SPECIAL MEETING AGENDA

1. CALL TO ORDER
2. ROLL CALL
3. APPROVAL OF AGENDA
4. APPROVAL OF THE MAY 12TH, 2026 REGULAR PLANNING COMMISSION MEETING MINUTES
5. PUBLIC HEARINGS
 - A. **CLASS A NONCONFORMING DESIGNATION – CAR WASH “GROVE STREET AUTO WASH” – 2171 GROVE ROAD** – TO CONSIDER THE CLASS A NONCONFORMING DESIGNATION APPLICATION TO PERMIT THE RENOVATION OF A VEHICLE WASH OF AN EXISTING LEGAL NONCONFORMING STRUCTURE

**Preliminary Site Plan, Special Land Use, and
Class A Non-Conforming Designation Review
For
Ypsilanti Township, Michigan**

Applicant:	Blackstar Building Group, Inc.
Project Name:	Grove Rd. Car Wash Renovation
Plan Date:	December 30, 2025
Latest Revision:	March 17, 2026
Location:	2171 Grove Road (south of Lakeview Ave.)
Zoning:	GB, General Business District
Action Requested:	Preliminary Site Plan, Special Land Use, Class A Non-Conforming Designation Approval

C-101

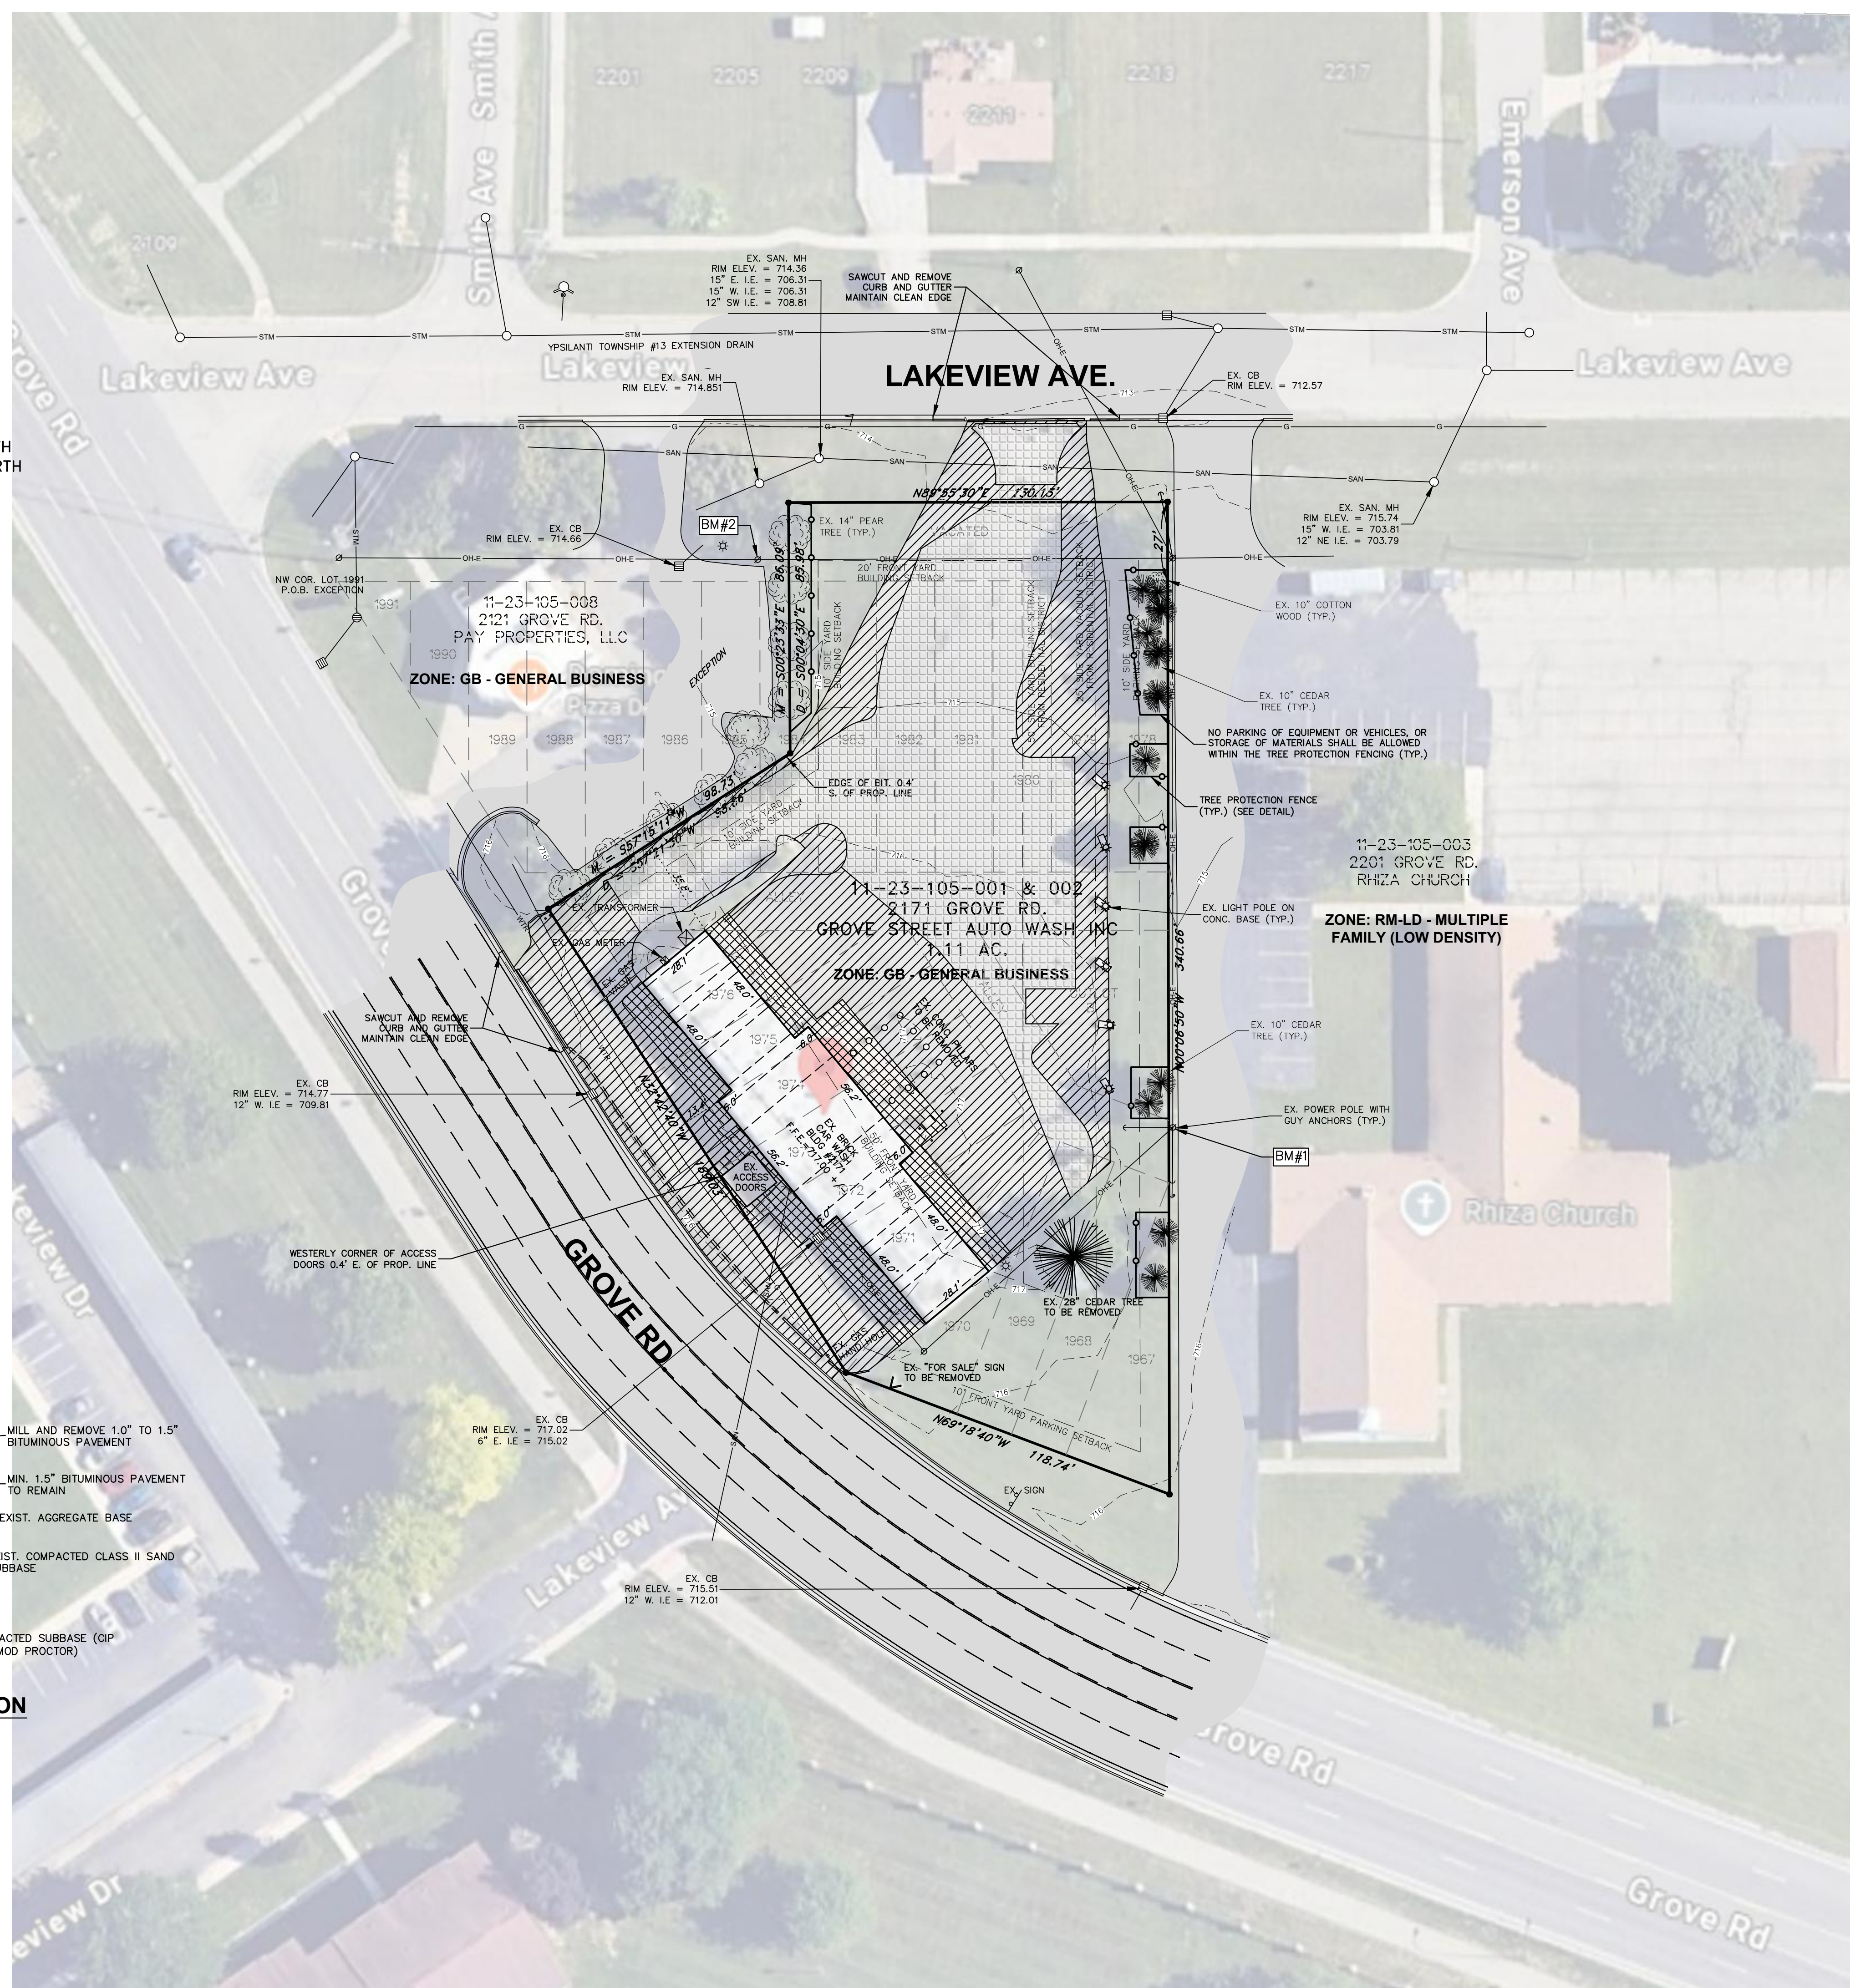
As requested, the following has been added to the Demolition Sheet (C-101) and the Grading Sheet (C-103). Our comments on the most recent set of plans are provided in *italics*:

- Tree Protection Fence detail. *This detail has been added to Sheet C-102, Site Layout Plan.*
- A Tree Protection Fence "symbol" should be shown around trees proposed to remain. Silt fencing is not sufficient. *Both sheets show the Tree Protection symbol around all trees to remain on the subject site, as well as the trees on the neighboring property (to the north/northwest). However, no Tree Protection Fencing is shown adjacent to this neighbor's five trees where the maneuvering lane is very close to the property line. It may be difficult to see, but the Tree Protection Fence symbol should also be shown adjacent to these five trees.*
- The Tree Protection Fence symbol should be added to the legend on each sheet. *Provided.*
- A note that states: "No parking of equipment or vehicles, or storage of materials shall be allowed within the tree protection fencing." *Provided.*

Items to be Addressed: *1) Add Tree Protection Fence detail to Demolition Sheet and Grading Sheet adjacent to five trees located on the neighbor's property to the north/northwest (along maneuvering lane in this vicinity.)*

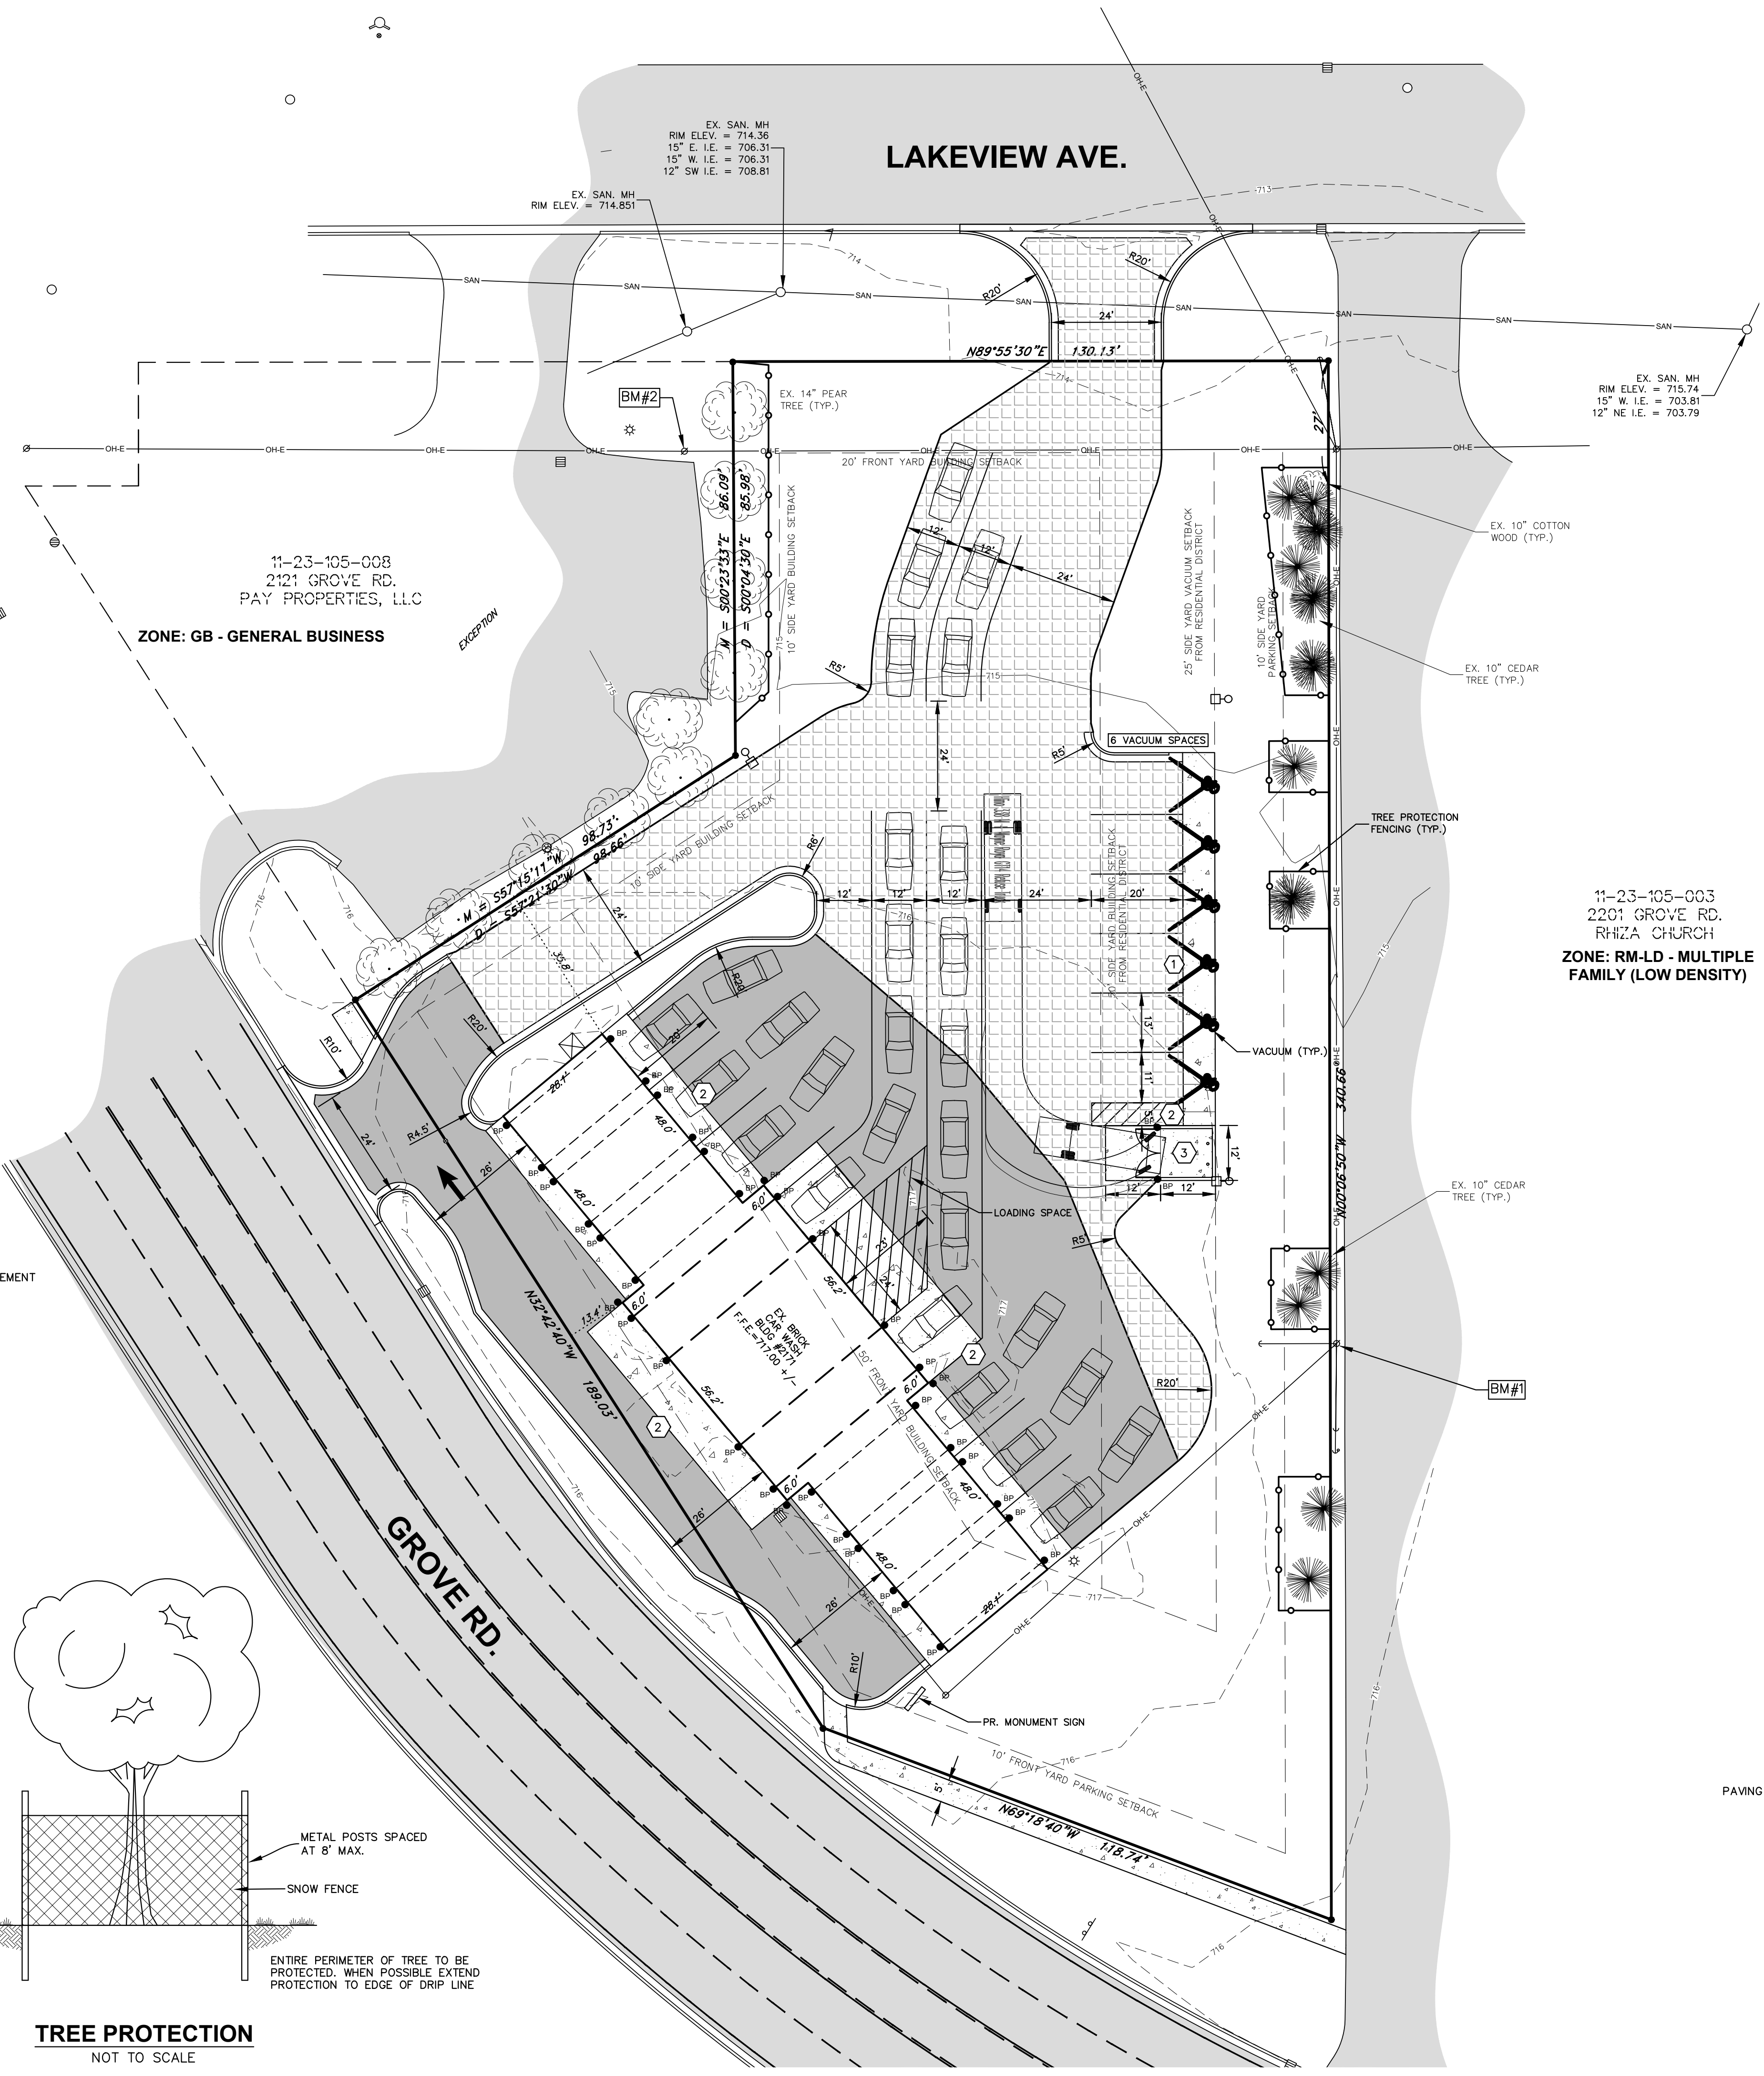
The amount of space for stacking into and out of the self-serve wash bays and automatic bays meets ordinance requirements. The stacking lanes should be painted onto the pavement, as shown on the Site Plan, to ensure the waiting vehicles do not block access to the vacuum stations.

In our previous review, we asked if vacuums will be available to customers who don't purchase a car wash. A note of Sheet C-102 states that vacuums are a "pay-to-use" amenity, so purchase of a car wash is not necessary.

A loading space on the northeast side of the building (facing Lakeview Ave.) is labeled on Sheet C-102. The space is approximately 600 s.f. (24' x 25'). The ordinance requires a loading space to be a minimum of 10-feet wide x 55-feet in length in a commercial district. The Planning Commission may consider these alternative dimensions if the applicant can demonstrate that this space will accommodate the businesses' needs. Notes on Sheet C-102 describes the vehicles maintaining this site as being vans that will deliver soap once a week between 7am-5pm. (Note that the location of this loading space will also require either a wall, fence or planting not less than six-feet high to screen the loading space from the adjacent residentially zoned property to the east.)

The plans show a five-foot wide sidewalk across a short distance of the Grove Rd. frontage, and then it directs pedestrians into the vehicle pavement at the wash bay exits. We don't consider this design safe, particularly for pedestrians using wheelchairs, and small children. The applicant is asking that this design be approved. However, the ordinance only allows the Planning Commission to vary the width of the safety path (not eliminate the path), or allow the applicant to place funds in escrow for future construction of the pathway.

An 8-foot-wide sidewalk/safety path is required along Grove Rd. However, the area that will contain the safety path is generally about 10-foot wide, except for one spot that is narrowed to about six-foot-wide to accommodate an automatic wash bay. The Planning Commission may vary the width of safety paths in those instances where strict adherence to these provisions cannot be met due to restriction of space. The Planning Commission should discuss the safety path with the applicant. (Note that placing an 8-foot-wide safety path along Grove Rd. will significantly reduce any space for a landscape screen in this same area; however, a narrower sidewalk (i.e., 5-foot-wide) across the entire frontage will improve pedestrian movements along this side of Grove Rd. and leave some room for perennial/shrub plantings.)
